**DOCUMENT 00 90 00
ADDENDUM**

ADDENDUM NO. [1] Date: March 1, 2018

**RE: SCHOOL DISTRICT OF HOLMEN
HIGH SCHOOL AND MIDDLE SCHOOL SECURE ENTRANCES
HOLMEN, WISCONSIN 54636
HSR PROJECT NO. 17071**

S201R

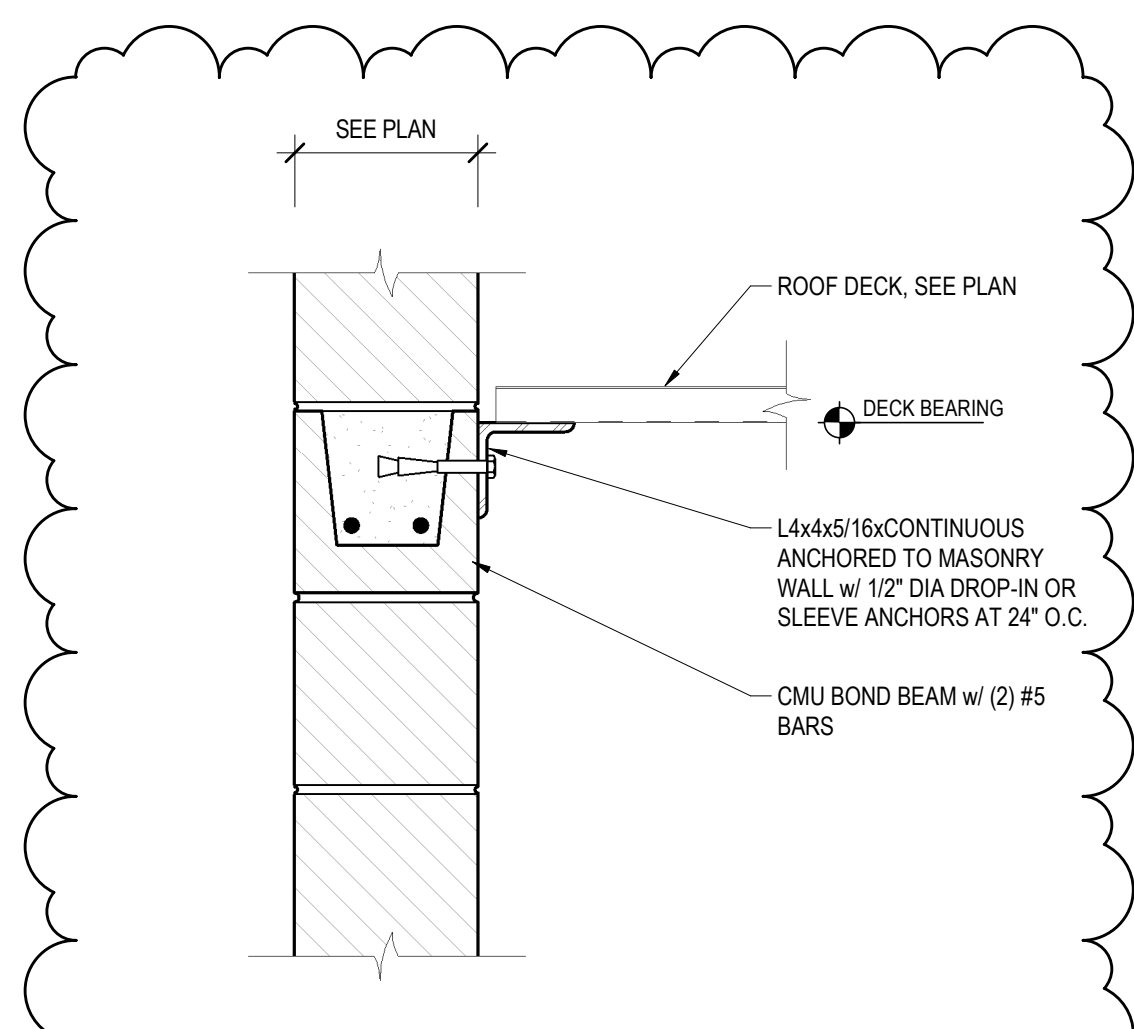
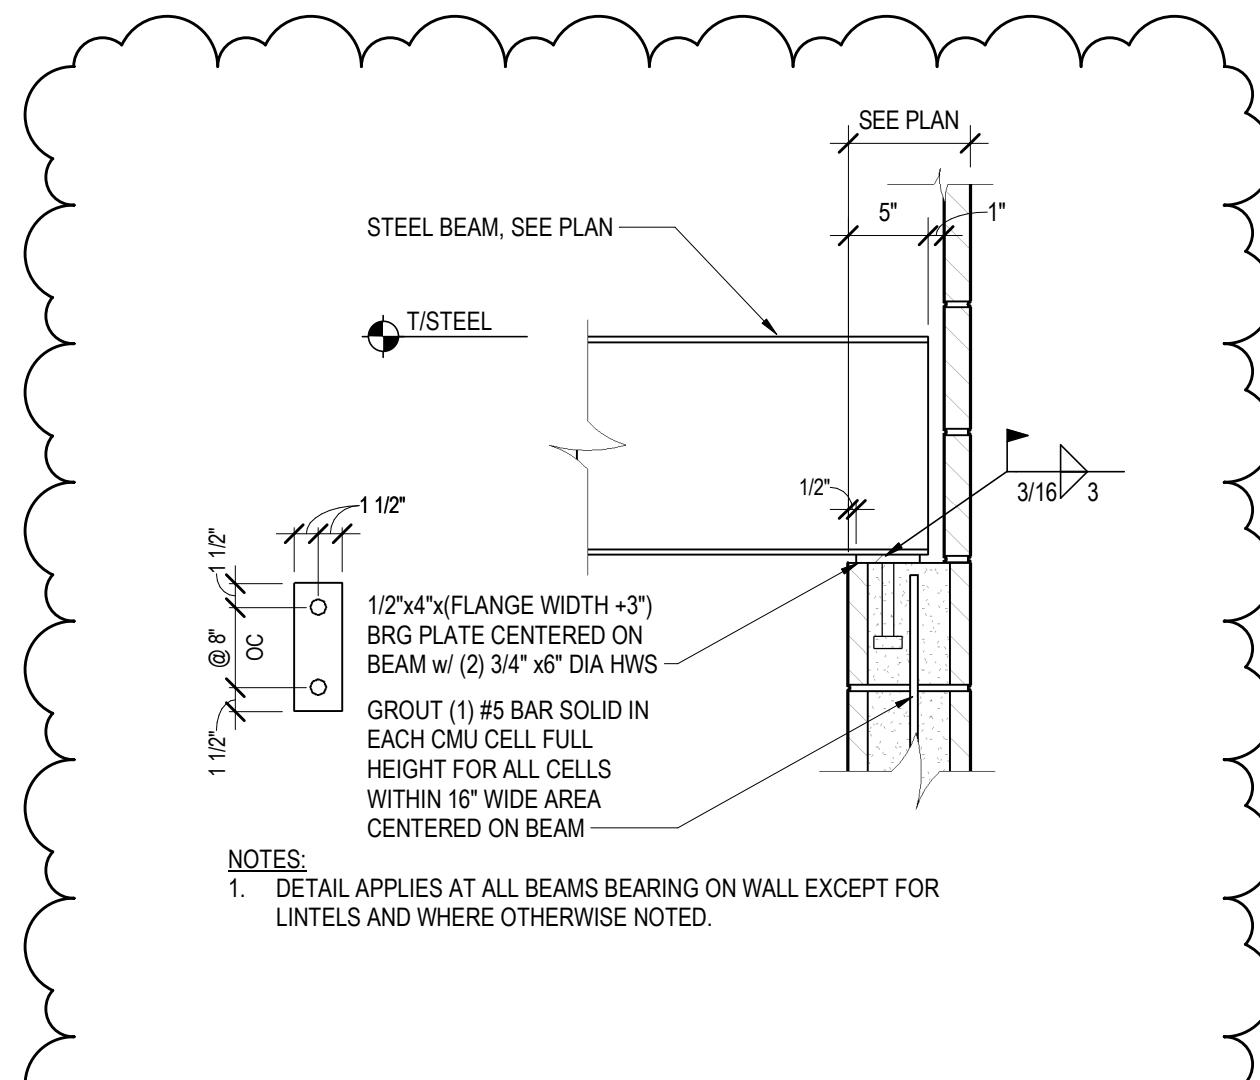
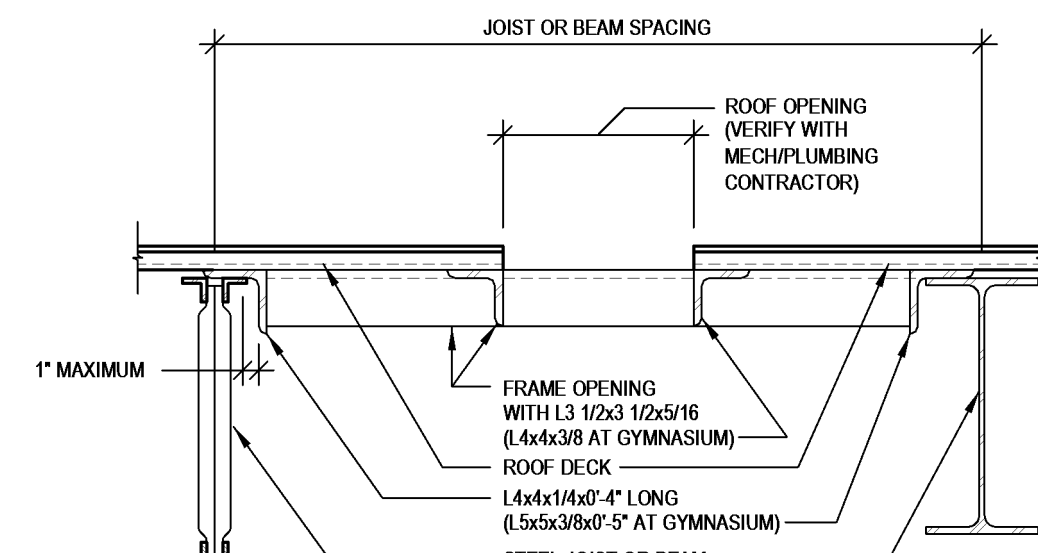
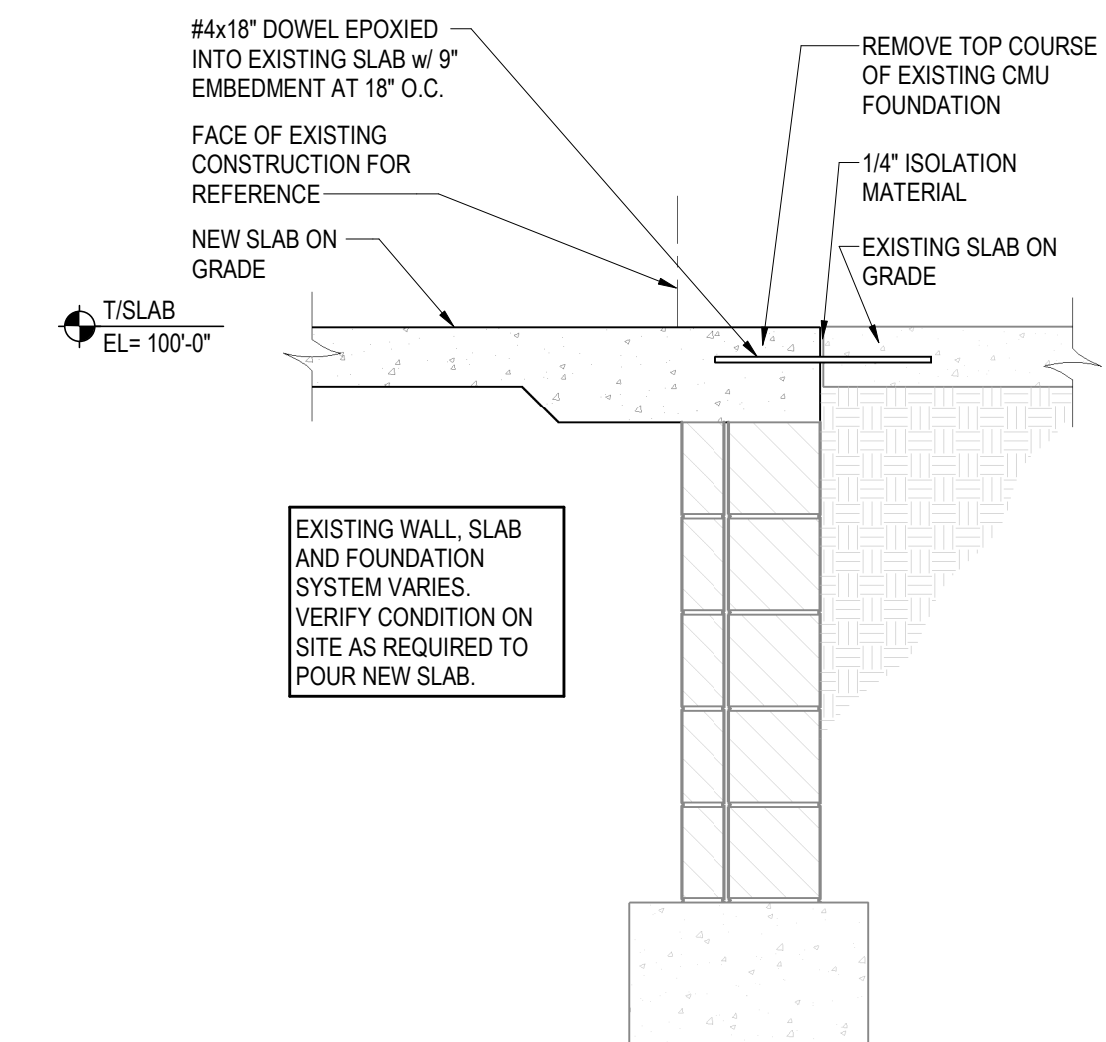
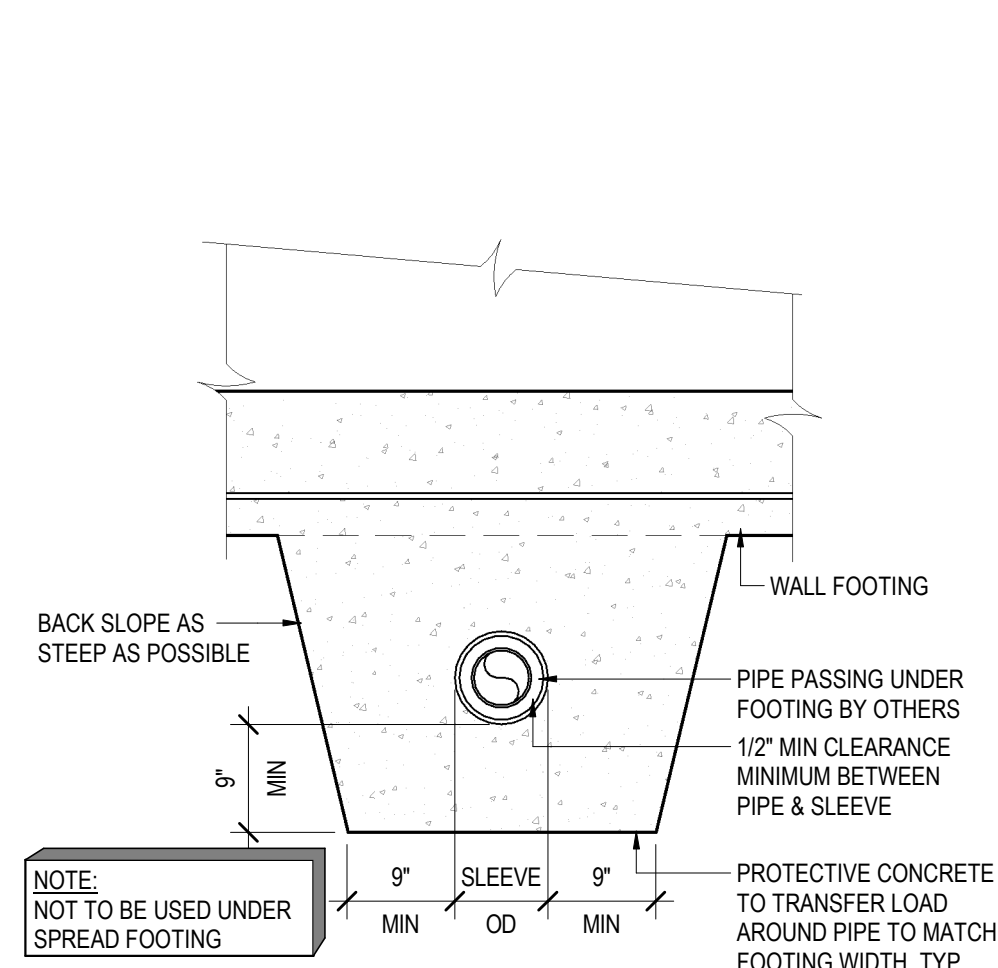
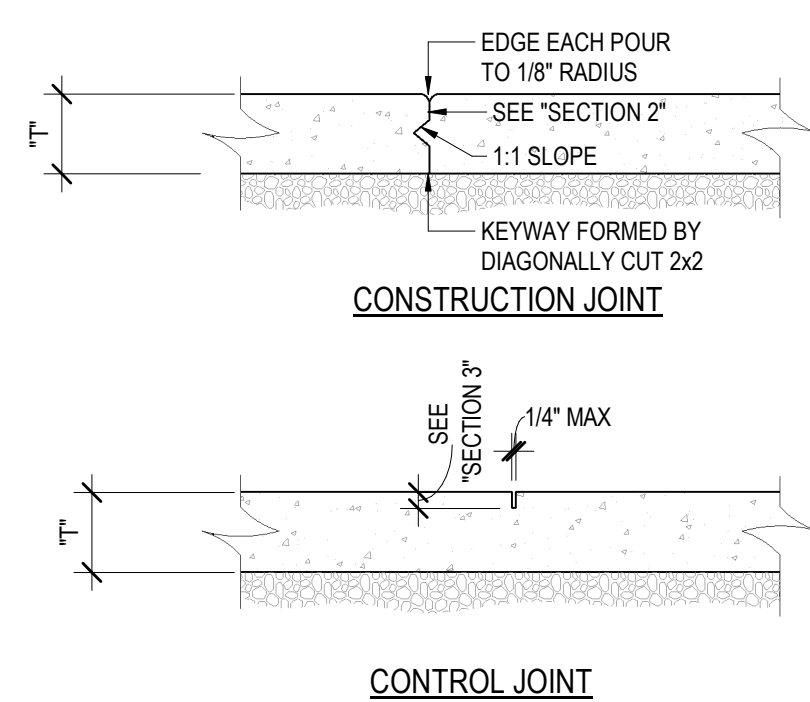
7. Sheet S100 FOUNDATION PLAN AND DETAILS
 - a. 6S100: Top of footing elevation is 96'-0" to match existing footing.
8. Sheet S200R FRAMING PLAN & DETAILS 24 x 36 attached hereto
 - a. Revisions clouded on plan.
9. Sheet S201R FRAMING DETAILS 24 x 36 attached hereto
 - a. Roof framing changed to wide flange beams.
 - b. Revisions clouded on plan.
10. Sheet M100R HVAC DUCTWORK AND PIPING REMODEL PLANS 24 x 36 attached hereto
 - a. Revisions clouded on plan
